AL No 413
(Slipper Tank
Attachment Nuts - Improved)

AP 4781A, Vol 2
Leaflet No G 8

Gnat T Mk 1 Aircraft - Mainplane - To Introduce Special Nut Part No 1820/2643 (Ref No 26DN/1497050) in place of Part No 1820/2617 (Ref No 26DN/8068) at the Slipper Tank Attachment to Mainplane

(Mod No Gnat/688)

Drwg. No. A. P. 4781A/G. 8/69
Sheet No. 1

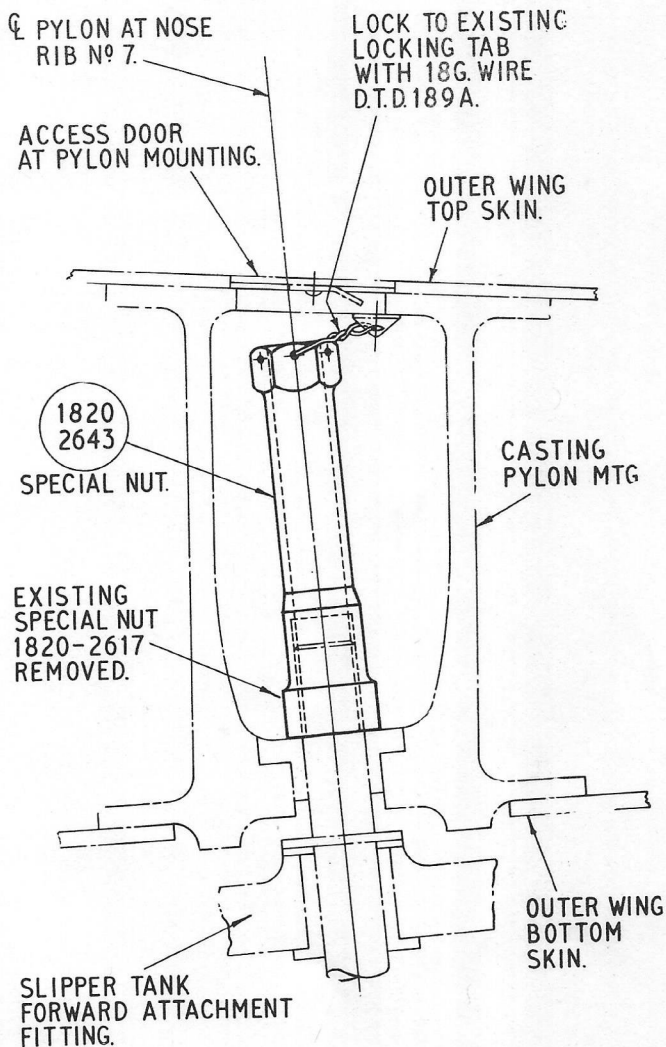
When wire locking the slipper tank forward attachment nuts, which are situated in the well of the pylon mounting casting, scratching of the painted surface may arise with possible subsequent corrosion of the casting. To prevent this circumstance, longer attachment nuts are introduced so that the wire locking is at the top of the casting well. Servicing will also be eased by reason of the greater accessibility of the attachment nuts.

(1) During replacement of wing slipper tanks, remove and discard special nuts, Part No 1820/2617 (2 off).

(2) Fit special nut, Part No 1820/2643, 1 at port wing, 1 at starboard wing and wire lock, using stainless steel locking wire, Specn DTD 189A, to existing locking tab, as shown on the drawing.
